Service Technical Information

MODEL NO. LCX-137 / 157 / 337 / 356 / 357 / AC1 / DR37
SUBJECT No power

REF.No. :G - A0 - 070 -E0

DATE :22. SEP. 2000

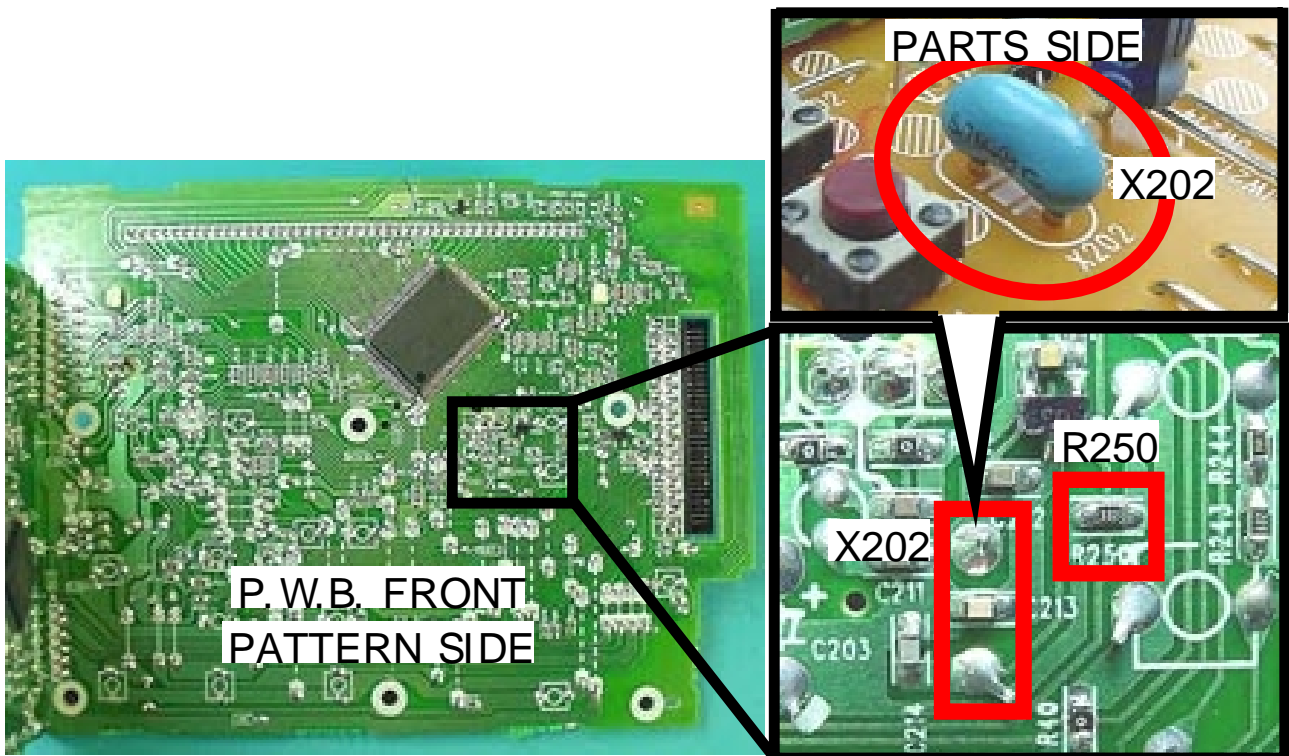
If " No Power " is reported, take the following procedure:

The clock is not displayed when AC Plug in, and pressing the power button does not bring any effect.

Take the following steps to replace the parts:

1. Remove the P.W.B FRONT from the front cabinet.
2. Change R250 from 3.3 kΩ to 1 kΩ.
3. Check if X202 on the P.W.B FRONT is oscillating. If not oscillating, change X202 to the new one shown in the table below.
